Before the  
**FEDERAL COMMUNICATIONS COMMISSION**  
Washington, D.C. 20554

Amendment of the Commission's Rules Regarding Dedicated Short-Range  
Communication Services in the 5.850-5.925 GHz Band (5.9 GHz Band)  
WT Docket No. 01-90

**Comments of 3M**  
Intelligent Transportation Systems  
Edmund J. Ring

Figure 1) 2-Ray Propagation Blocking Path Analysis

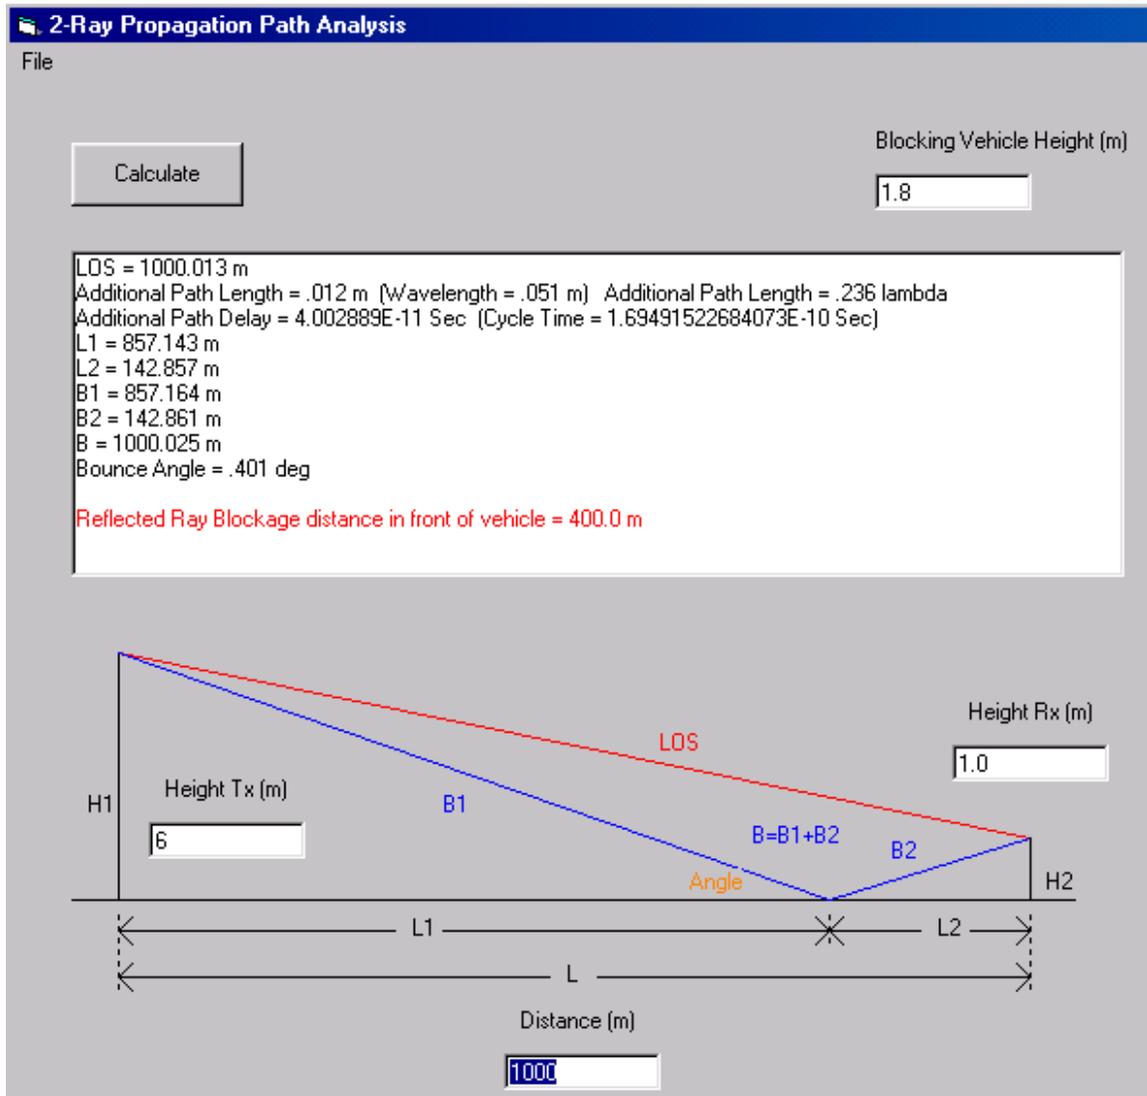
Third, a clear propagation path for the reflected ray is not always available due to intervening vehicles that **will** be present in an urban environment. If a blocking vehicle is located between the reflected ray path and the receiving vehicle, the reflected ray will be blocked. An example of this is shown in Figure 1. Here the vehicle height is set at 1 meter as defined in the technical definition of the **proposed antenna height correction factor**. The transmitting antenna height is 6 meters and the blocking vehicle height is 1.8 meters. It can be seen in Figure 1 that any blocking vehicle in the 400 meters (over 4 football field lengths) from the receiving vehicle to the transmitting antenna will block the reflected ray from reaching the receiving vehicle.

Figure 2) 276 Rays generated between Transmitter and Receiver in an Urban Canyon

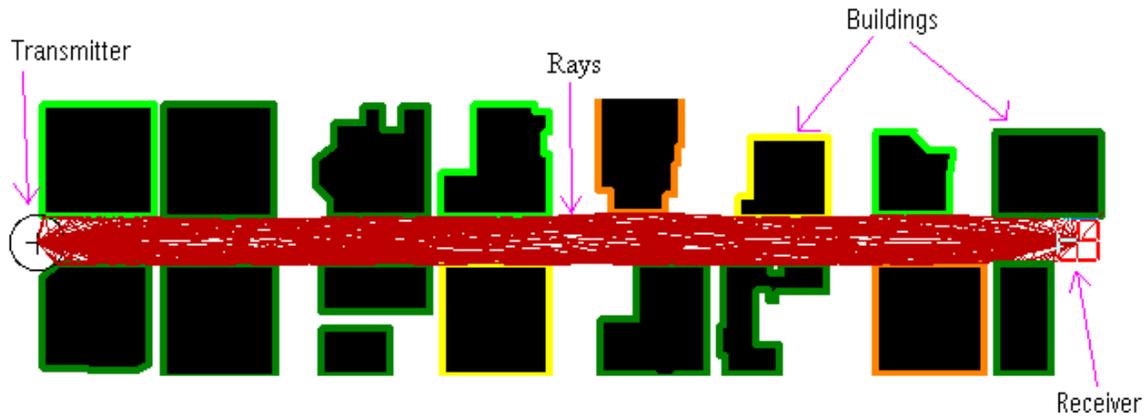
In Figure 2, a simulation of a single receiving point 1 meter in height, at 455 meters from the transmitter at a height of 6 meters, is shown. This simulation accounts for the presence of buildings along the path. No other vehicles or reflection sources are included in these simulations. It can be seen that with the inclusion of buildings along the path, the 2-Ray propagation model no longer accurately represents the received signal.

In fact, 276 individual rays were generated, many with amplitudes approximately the same as the Line of Sight ray. Each red line represents a single ray path between the transmitter and receiver. The addition of other reflections sources will generate many additional ray paths between the transmitter and receiver.

Figure 3) Signal Strength along an Urban Canyon

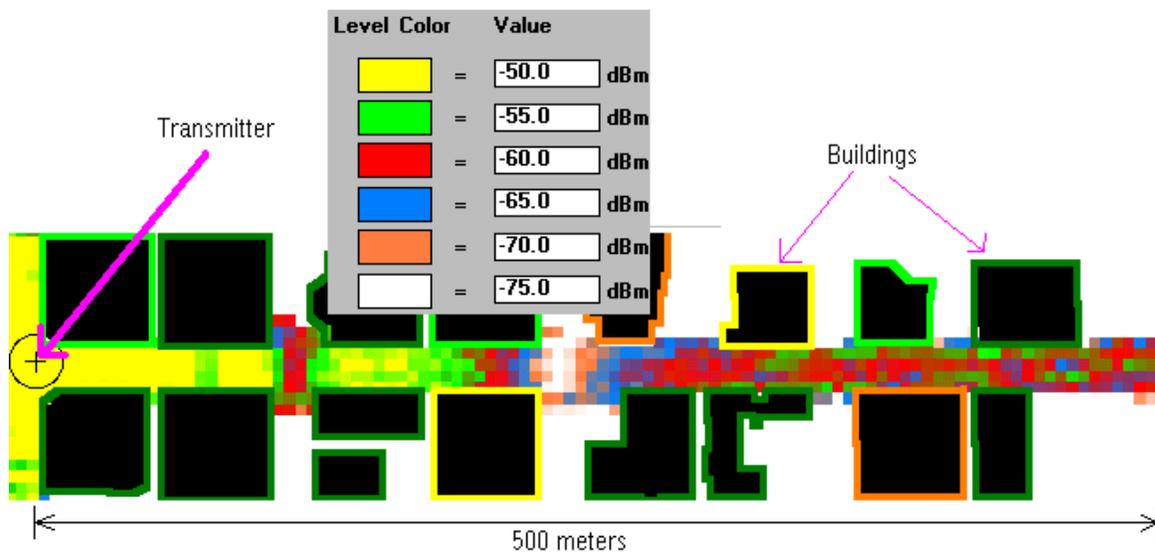
In Figure 3, the signal strength along the length of an urban canyon is plotted. From this plot it can be seen that the signal strength varies significantly along and across the roadway and does not follow the predictions of the 2-Ray model. This simulation

accounts for the presence of buildings along the path. No other vehicles or reflection sources are included.

In conclusion, it can be seen that the **proposed antenna height correction factor** is invalid for the environments that DSRC communication links will operate in. Therefore, the **proposed antenna height correction factor** should be eliminated from consideration.
